CIS-ASY-R30-3
18" HV chamber with spherical electrode and CEBAF-type anode

ANODE assembly findings

Jan 31 2022
Carlos Hernández-Garcia

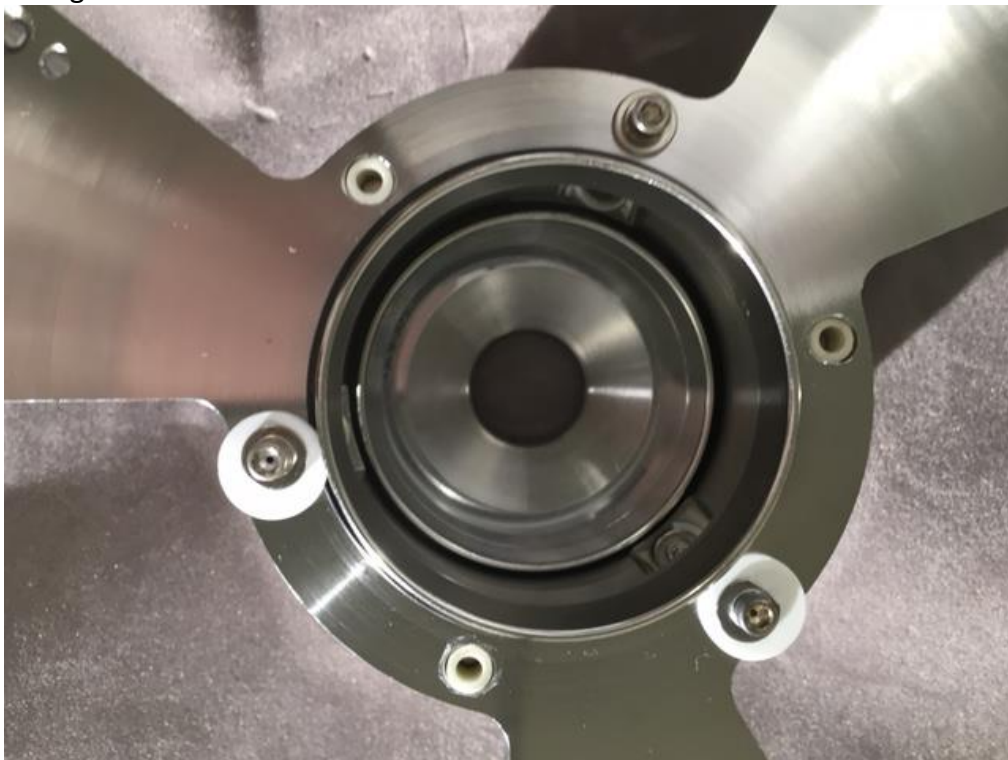
Anode-cathode gap: is it 6.27 cm? or 2.506 in=6.36 cm?
Need to check with Shaun

The anode assembly was measured using a Vernier caliper. Then it was taken apart and inspected, and every piece thickness was measured for checking against the measured total length.

This is the back end view of the assembly before it was taken apart. Notice there is a ceramic washer missing.

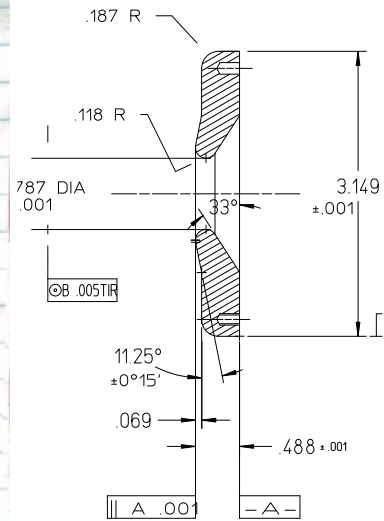
Calculation:

$$0.415 + 0.060 + 0.133 + 1.173 + 0.060 + 0.135 + 0.25 = 2.226$$
[illegible]

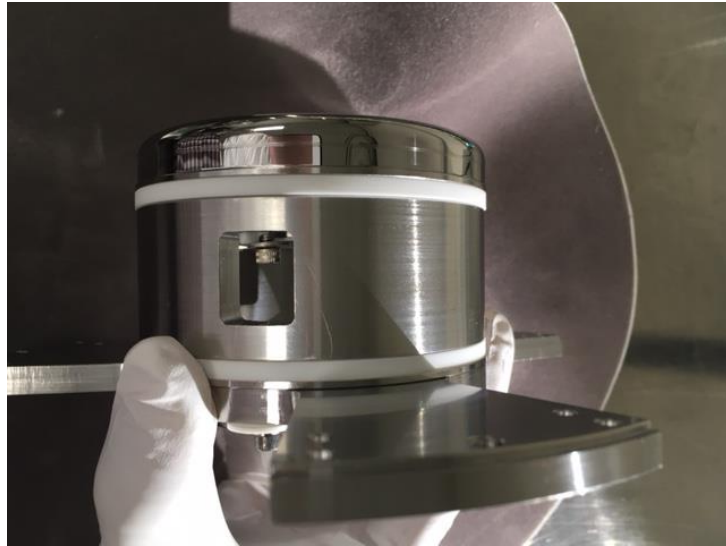
This anode has two ceramic rings that electrically isolate the anode from the tube, and the tube from the frame (spider?) at ground.

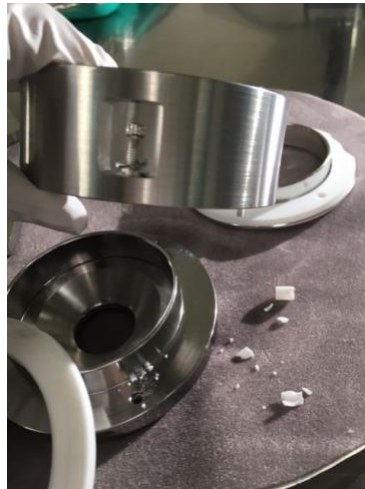
Each ceramic ring seems to be shielded from the beam line-of-sight by a thin SS short tube. One of the ceramic rings is chipped off. The other one is ok, but I do not know if there are spare ceramic rings. The ceramic bushing that isolates the screw from the anode came off in little pieces. Need to check for spares or order more.

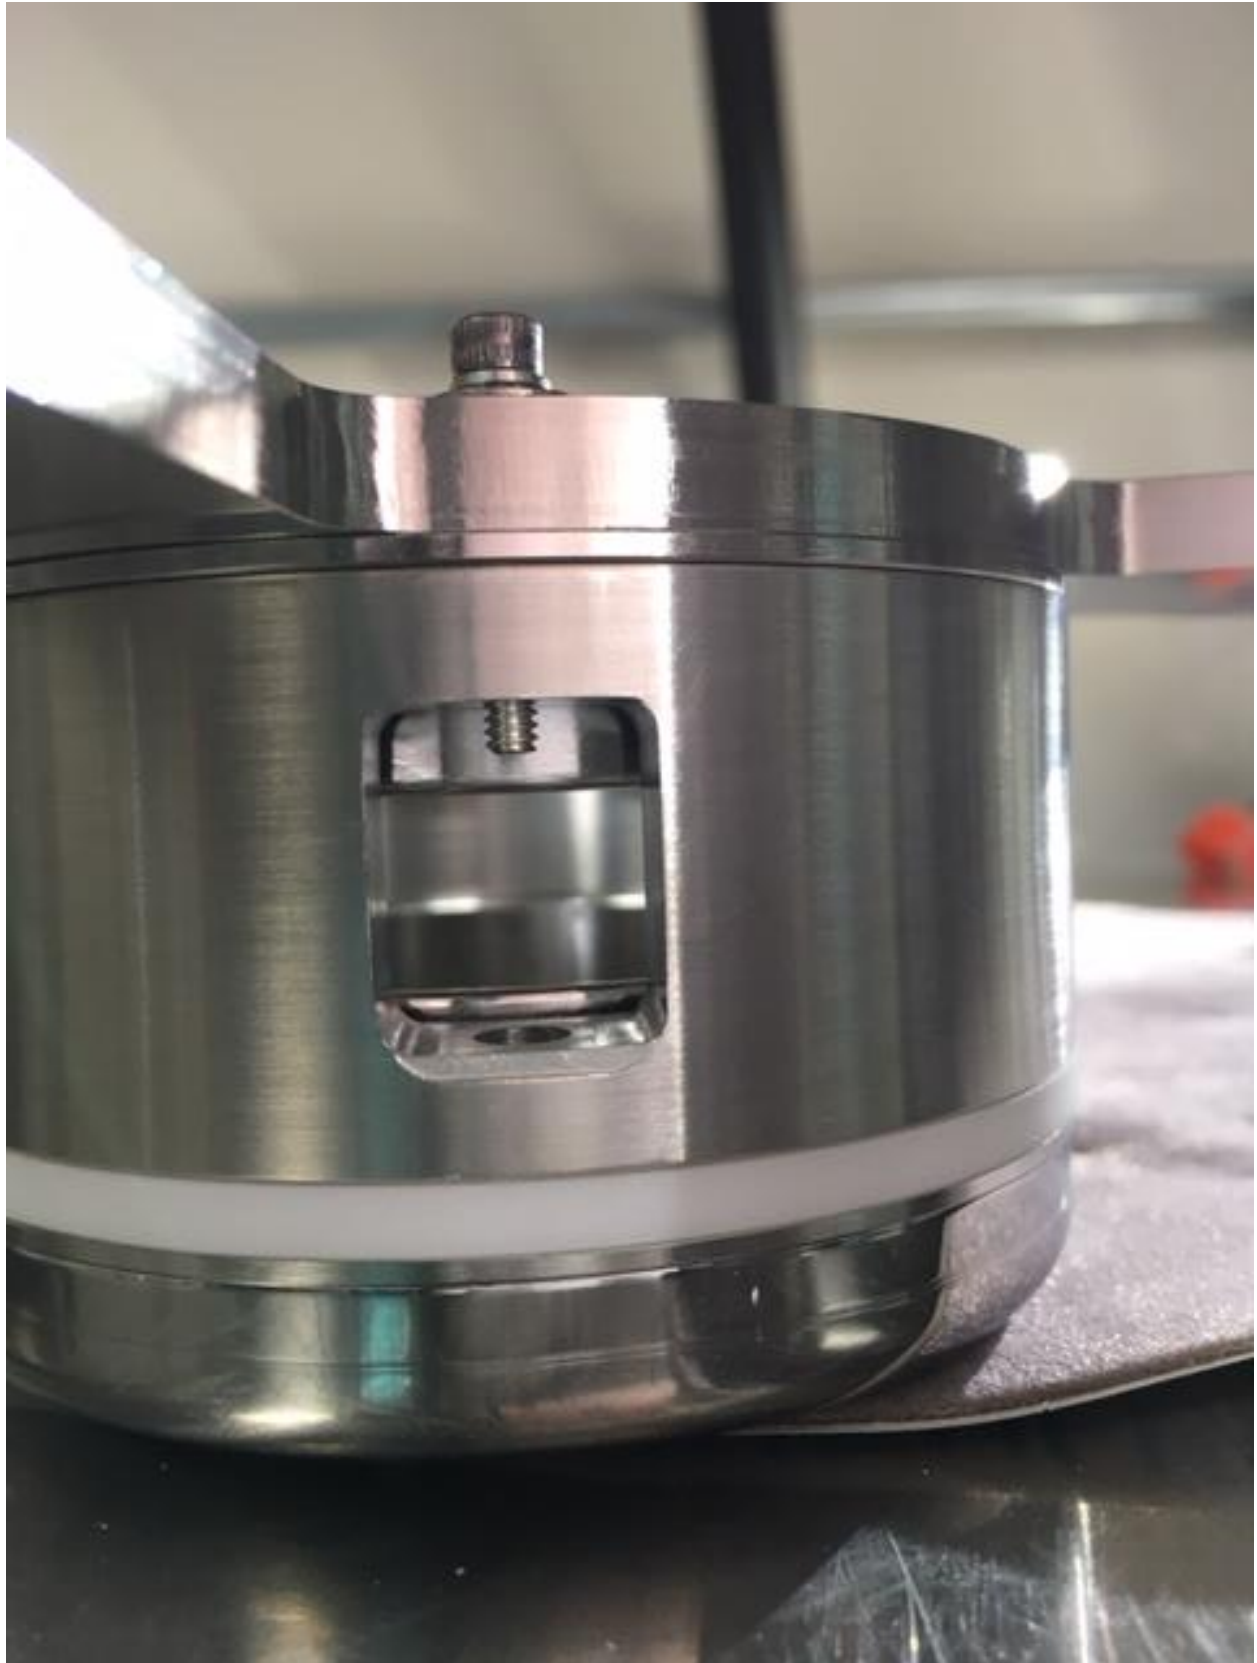
The existing screws are too long if the back ceramic ring is removed for grounding the tube.

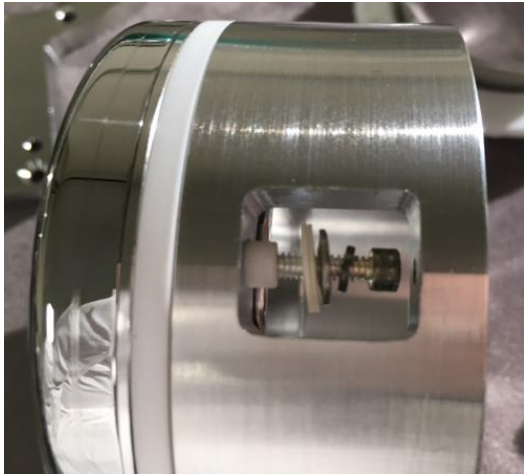
With the present anode tube 'apertures' is very difficult to insert the screw assembly to isolate the anode. A normal Allen wrench won't fit to tighten the bolt.
